OSM/EE DECISION SHEET

Category	Standard:	Clause	Document no.
TRON	EN 60065:2014	14.6.3.3	OSM-EE 18/6
Subject		Key words	Meeting
Fuses in parallel		Fuse	London 2018

Standard: EN 60950-1:2006 + A11:2009 +A1	Sub clause: 2.7.4	Sheet No.: DECISION 11/3 Page 1 of 1
Subject: Fuses in parallel connection, in the input circuit.	Key words: Parallel, Fuses, Input Circuit	Meeting: Vienna, 2010 Agenda item 8.2, Brussels item 5.1.6

The schematic shows the primary circuit of a commercial high power amplifier:-

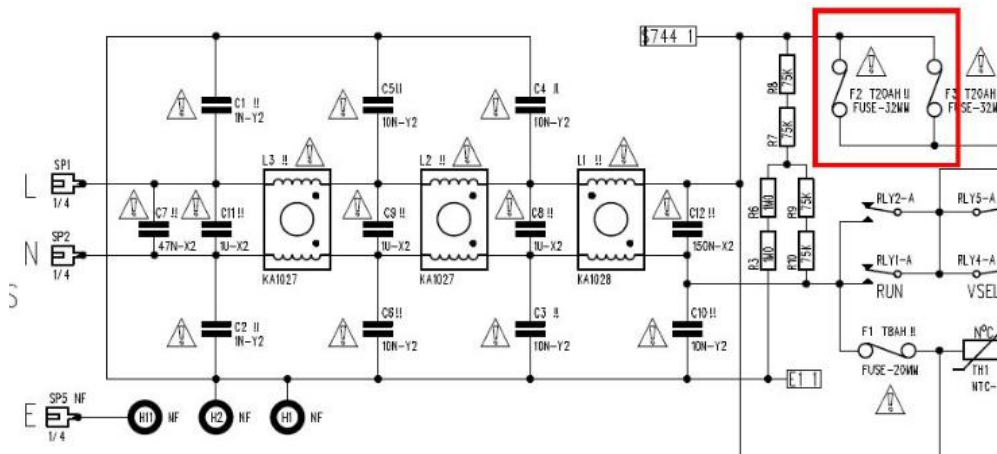
Clause 14.6.3.3 of IEC 60065 appears to not allow fuses to be in parallel with each other. (Although the text is not 100% clear because “a fuse” is stated rather than “fuses”):-

This is clearer in that it states that a fuse shall not be connected in parallel with a component that could fail to a low-resistance state. I guess that a fuse in parallel with another fuse is OK for IEC 62368-1 because the 2nd fuse would not generally fail to a lower resistance state than it was to start with.

Can we use this logic to accept the fuses in parallel in an amplifier tested to 60065?

OSM does not see a technical reason to reject fuses in parallel (not limited to 2).
It should be clarified that the breaking capacity of each of the fuses must be sufficient to cover the total available breaking current of the circuit.

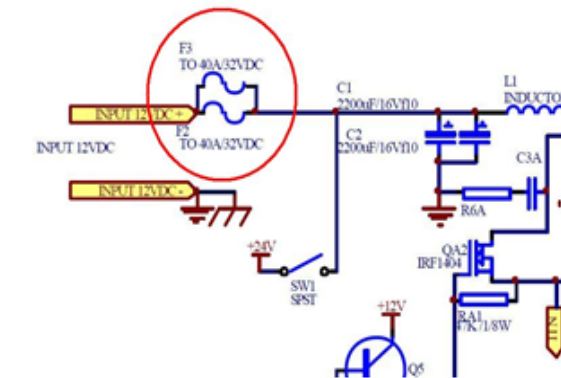
Are two fuses in parallel connection allowed in the input circuit?

Certain low voltage circuits may be rated at 100 A or more (e.g. 3V3/125A). Suitable fuses of such a rating are not available. To protect such circuits, some manufacturers have proposed the use of 2 fuses placed in parallel.

OSM does not see a technical reason to reject fuses in parallel (not limited to 2).

It should be clarified that the breaking capacity of each of the fuses must be sufficient to cover the total available breaking current of the circuit.

MT2 agreed with the decision of the OSM, but felt that it should be clarified that the breaking capacity of each of the fuses must be sufficient to cover the total available breaking current of the circuit.
